PERMIT

TAX ID # 04371410
ON-SITE SEWAGE DISPOSAL SYSTEM
HOWARD COUNTY HEALTH DEPARTMENT
BUREAU OF ENVIRONMENTAL HEALTH

SUBDIVISION: The Chase at Stoney Brook LOT NUMBER: 17

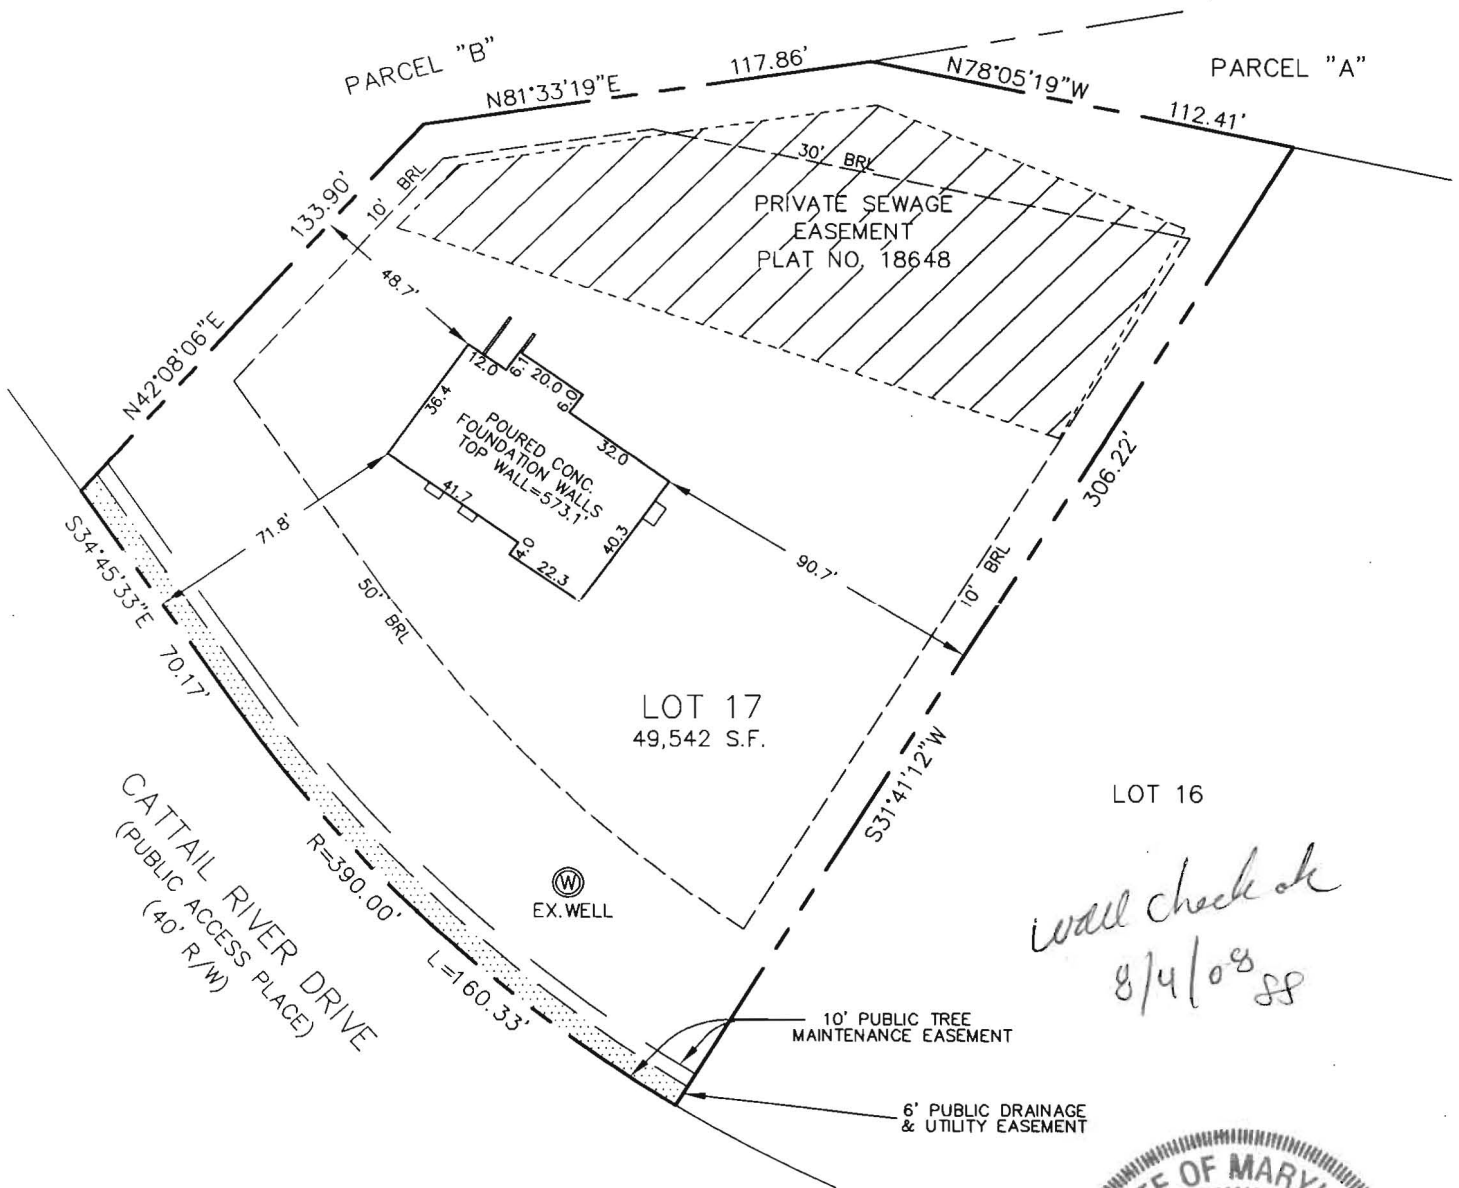
8/5/08 Keep tank 20'
from dwelling. D box
to be placed top center
of corner. Install
3 x 92' trenches on corner

running towards lot 16. (K)

INSTALLATION: 9/19/08 Tanks, distribution box and plumbing
installed (BB) 9/22/08 Most of system finished. Installer
has half of bottom trench left to do but backhoe broke.
Gave O.K. to cover everything when done (BB)
